WSN9- Replacing Plastic Slide On Three-Point Front Seat Belt (Workshop Campaign)

Model Line: **Macan (XAB)**

Model Year: **As of 2024 up to 2026**

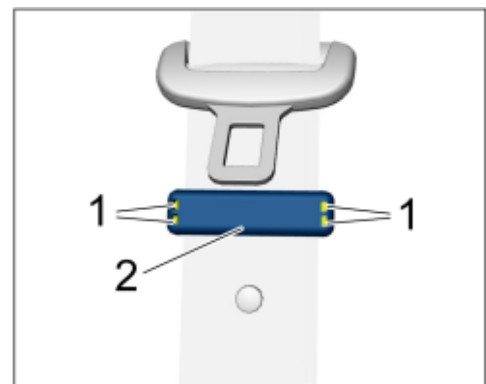
Cause: **On the affected vehicles, there is a possibility that on the passenger side rattling noises could occur on the B-pillar due to the free-swinging belt tongue of the three-point seat belt.**

Action: Replace plastic slide on the three-point seat belt on the passenger side with a plastic slide with belt loop.

- Work Procedure:
- 1 Loosen retaining lugs ⇒ *Plastic slide without belt loop*
 -1- on the plastic slide ⇒ *Plastic slide without belt loop*
 -2- using a suitable tool, ⇒ *Plastic slide without belt loop*
 -2- open plastic slide and remove.
 - 2 Fasten **new** plastic slide with belt loop ⇒ *Plastic slide with belt loop*
 -1- to belt strap. Make sure that the belt loop under the belt tongue is pointing ⇒ *Plastic slide with belt loop*
 -2- upwards.

- 3 Fasten the removed plastic slide **without** belt loop to the three-point seat belt on **the driver side**.
- 4 Enter the campaign in the Warranty and Maintenance logbook.
